Board of Architectural Review

DATE: November 20, 2019
TO: Board of Architectural Review Chair and Members
THROUGH: Jason Sutphin, Community Development Division Chief (JDS)
FROM: Tommy Scibilia, BAR Liaison (TS)
SUBJECT: **9571 Fairfax Boulevard**

1. Case Number:	BAR-19-00789
2. Addresses:	9571 Fairfax Boulevard
3. Request:	New commercial building and site improvements
4. Applicant:	9571 Fairfax Boulevard, LLC
5. Applicant's Representative:	Stuart Schooler
6. Status of Representative:	Property owner
7. Zoning:	CG Commercial General, Architectural Control Overlay District

- WD-1 SHERWIN-WILLIAMS SOLID STAINED WOOD 2X6 - OTTER
- M-1 SHERMAN-WILLIAMS CHARCOAL FINISH
- L-1 CONTECH WALL MOUNT LIGHTING FIXTURE - CY3
- CMU-1 YORK BUILDING PRODUCTS SPLIT FACE - ARCTIC WHITE

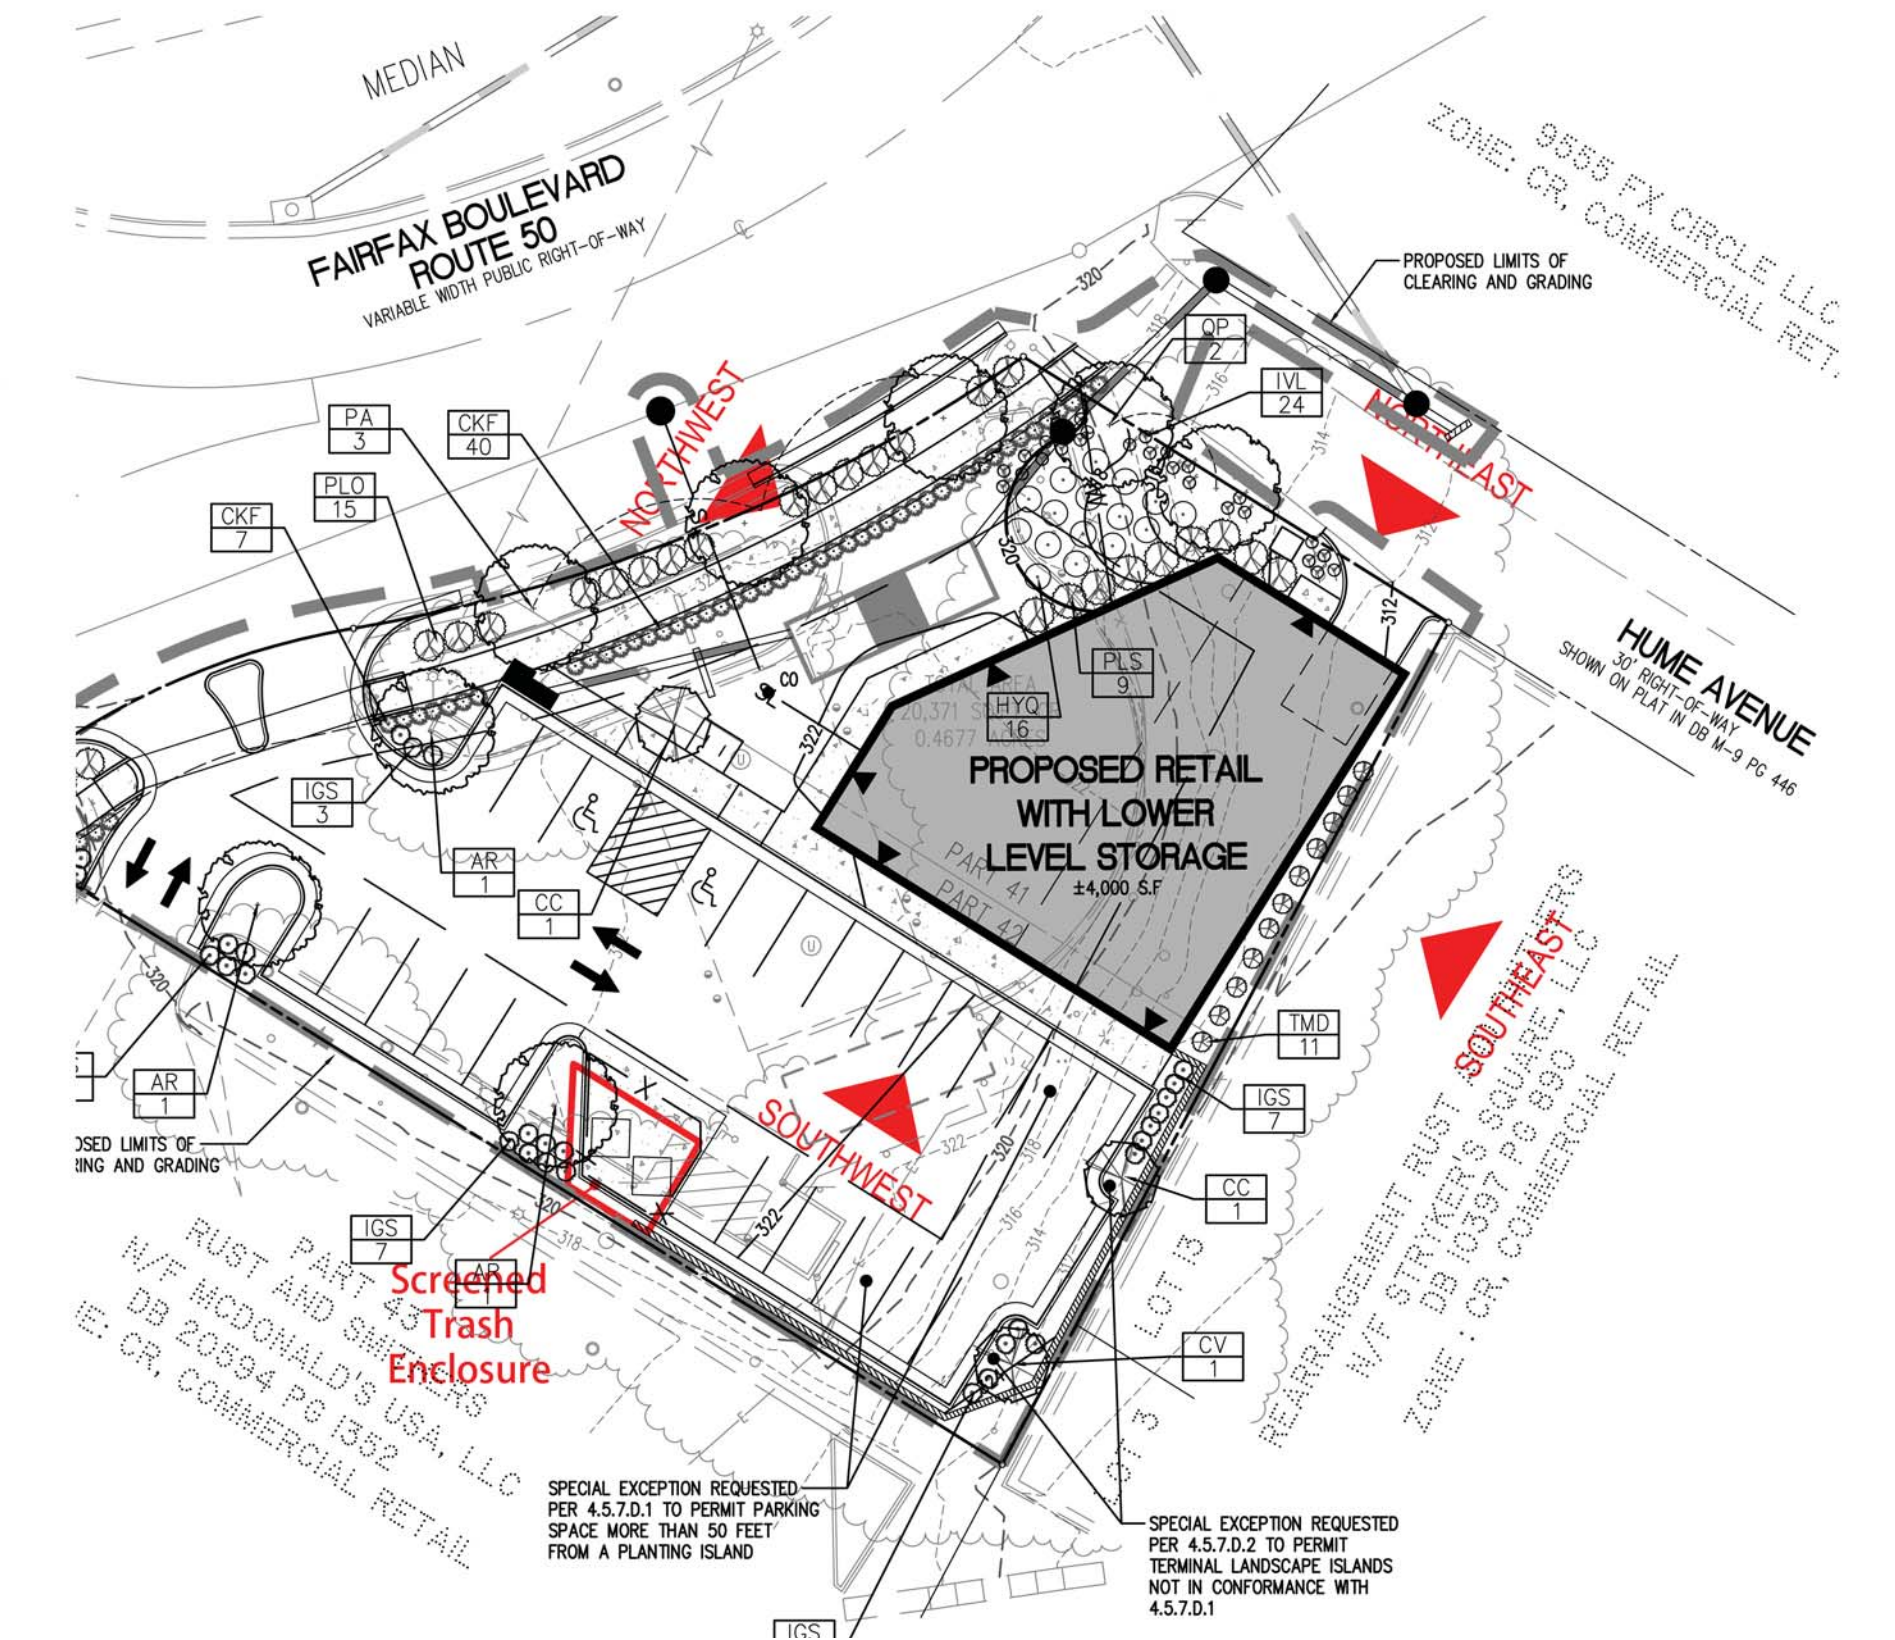
Staff believes that the use of reveals to create bays, the varied roofline, and the wall recesses would all help articulate the form of the building.

Staff finds the elevated roofline of the western corner to give this portion of the building visual prominence. The flat roof form is a contemporary design treatment consistent with neighboring building forms.

Staff believes that the entrances and storefront would be well-integrated and located in highly-visible locations on the building. The openings on the northeastern façade proposed for the Option 1 rooftop seating reflect the verticality of the other openings in the building design, and create additional transparency. Spandrel glass is not proposed.
